Block 16 Section 10

1.0 Context and Character

Built form and scale London Circuit Elevation

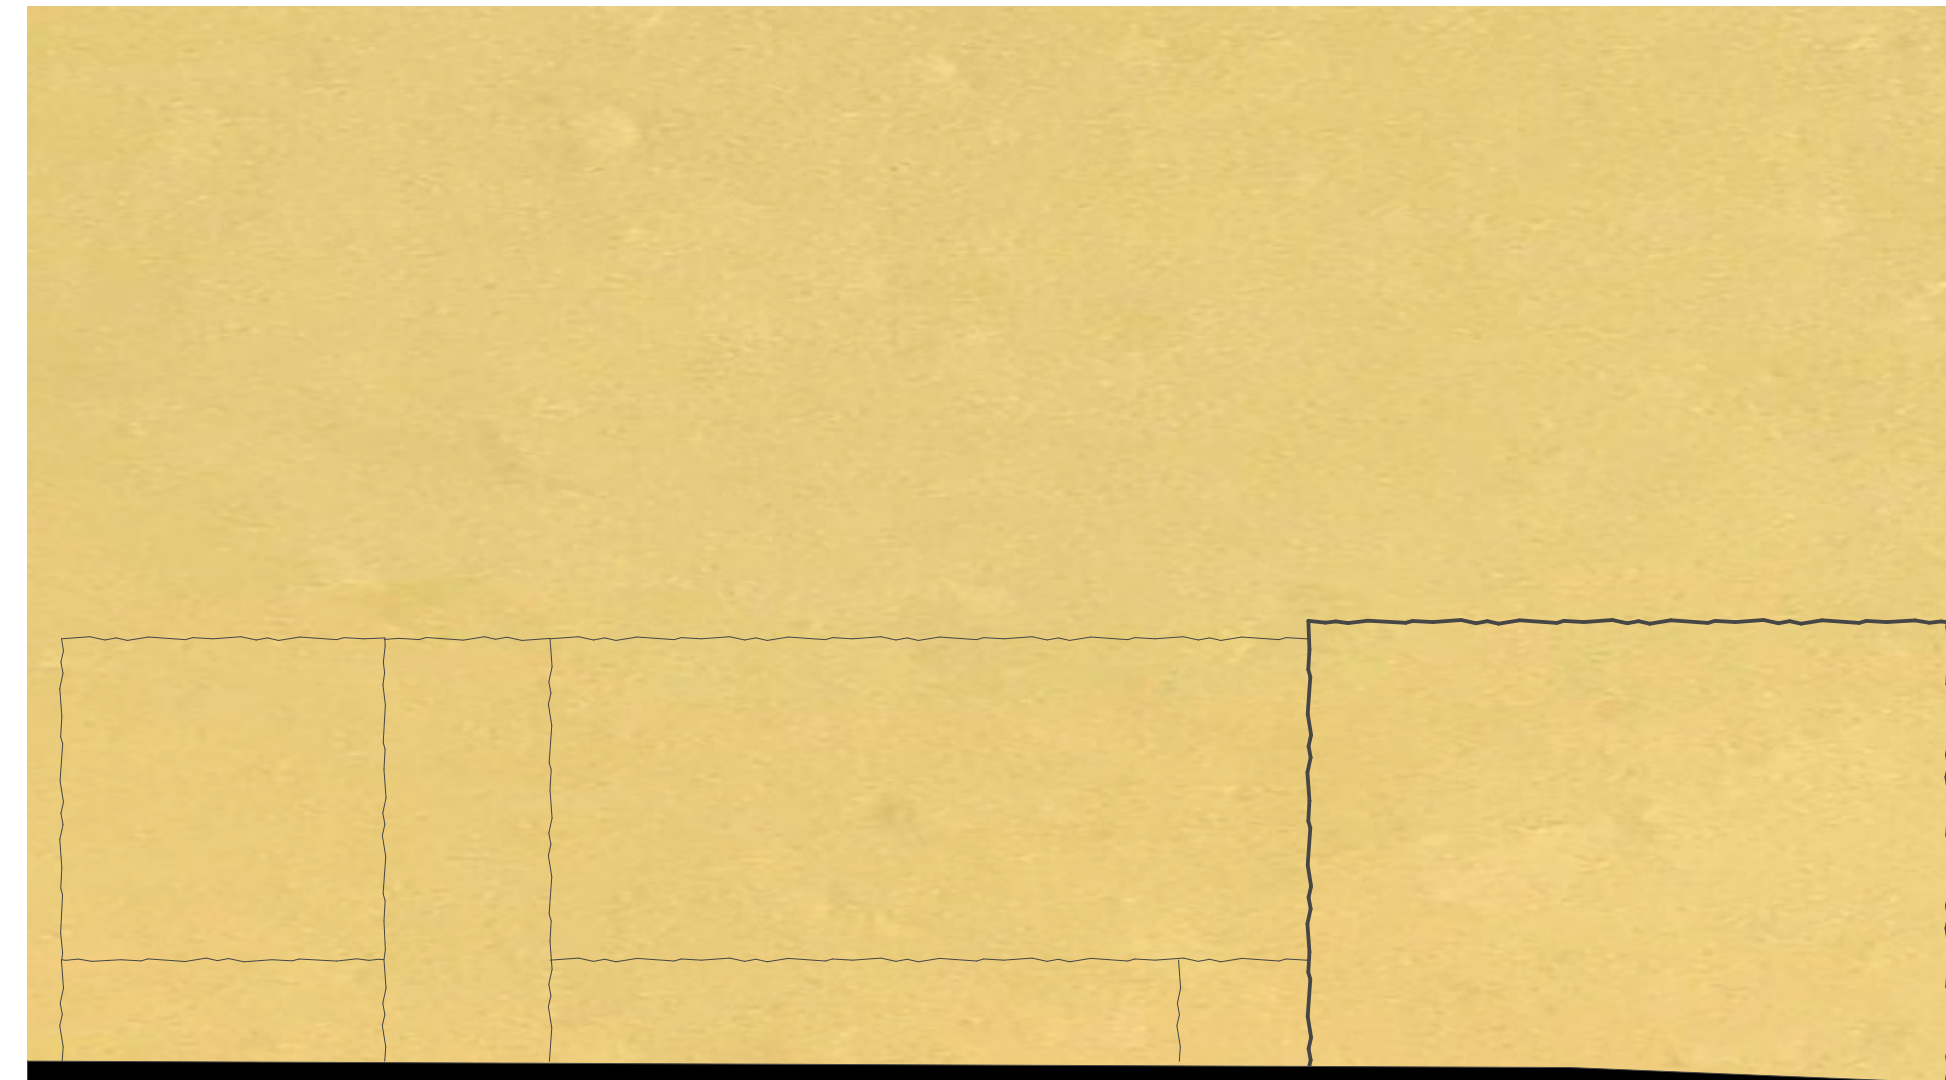
5.1 Acknowledging the length of Building 1 proposed to London Circuit has precedent on London Circuit developments, the Panel considers that it is not the predominant condition. As such, the Panel considers the current building mass and bulk to London Circuit would benefit from further design development to provide a greater level of articulation, site permeability and creation of inner urban space as a means to break down the current building bulk. This may include consideration of multiple and separate building forms, central and peripheral open access ways and more generous public courtyards. The Panel therefore recommends the proponent team investigate how the preliminary building form alignment diagram could be reinterpreted to provide an alternate outcome for the development.

Built form and scale Parkes Way Elevation

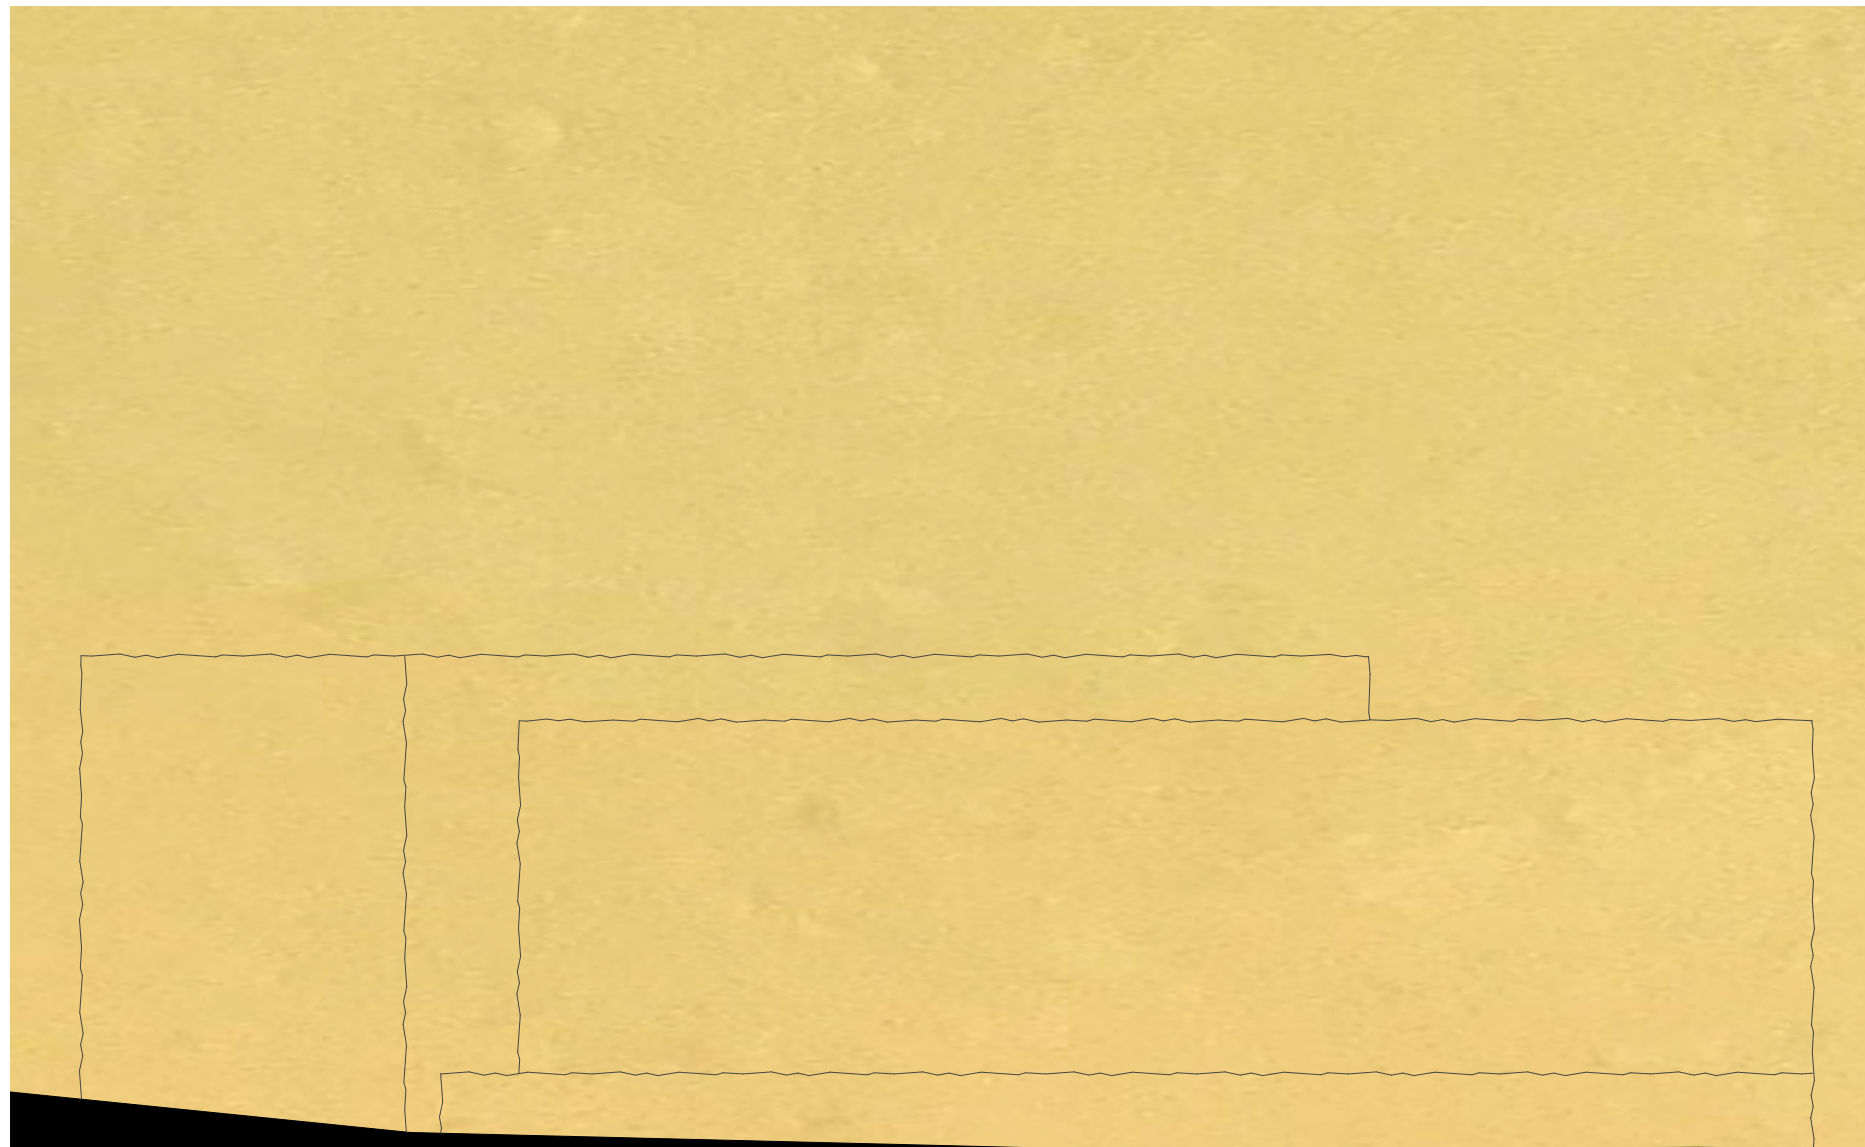
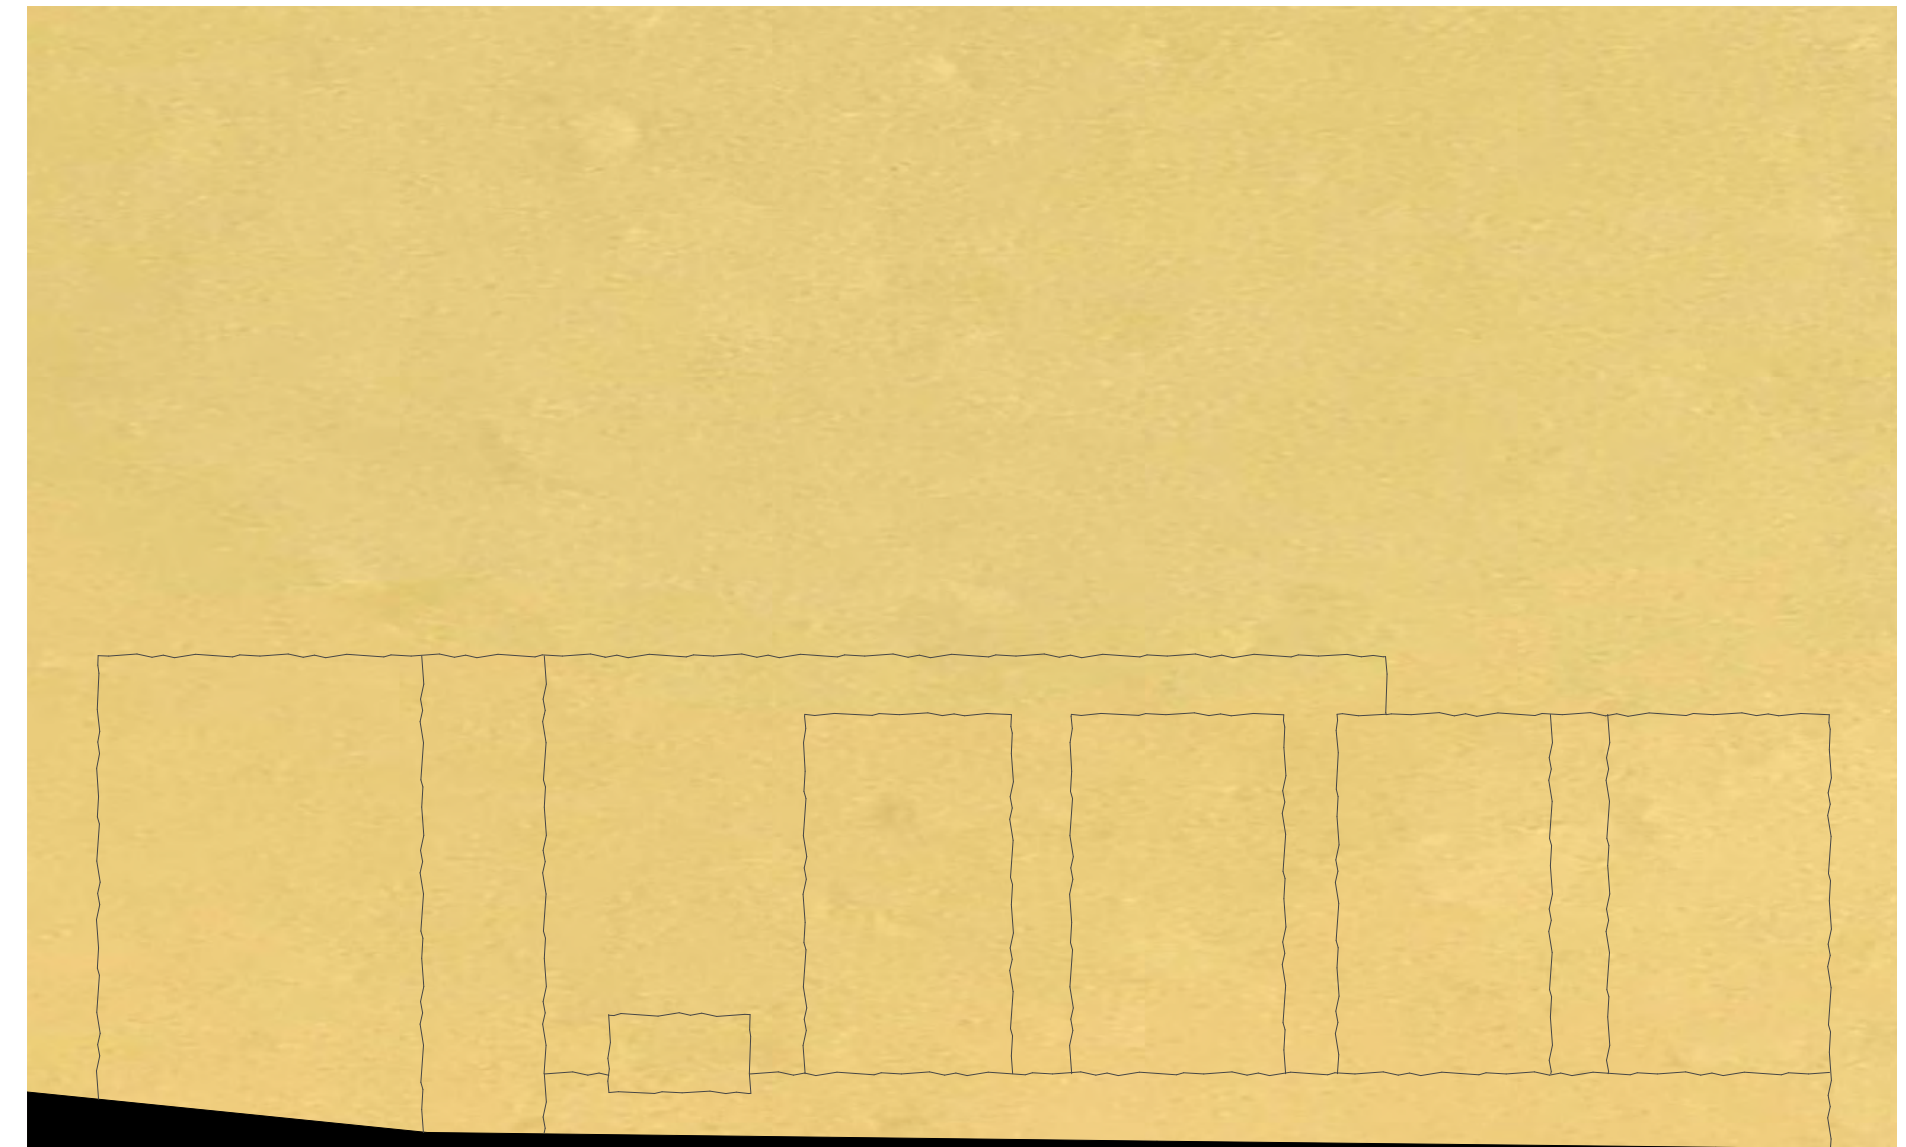
5.1 Acknowledging the length of Building 1 proposed to London Circuit has precedent on London Circuit developments, the Panel considers that it is not the predominant condition. As such, the Panel considers the current building mass and bulk to London Circuit would benefit from further design development to provide a greater level of articulation, site permeability and creation of inner urban space as a means to break down the current building bulk. This may include consideration of multiple and separate building forms, central and peripheral open access ways and more generous public courtyards. The Panel therefore recommends the proponent team investigates how the preliminary building form alignment diagram could be reinterpreted to provide an alternate outcome for the development.
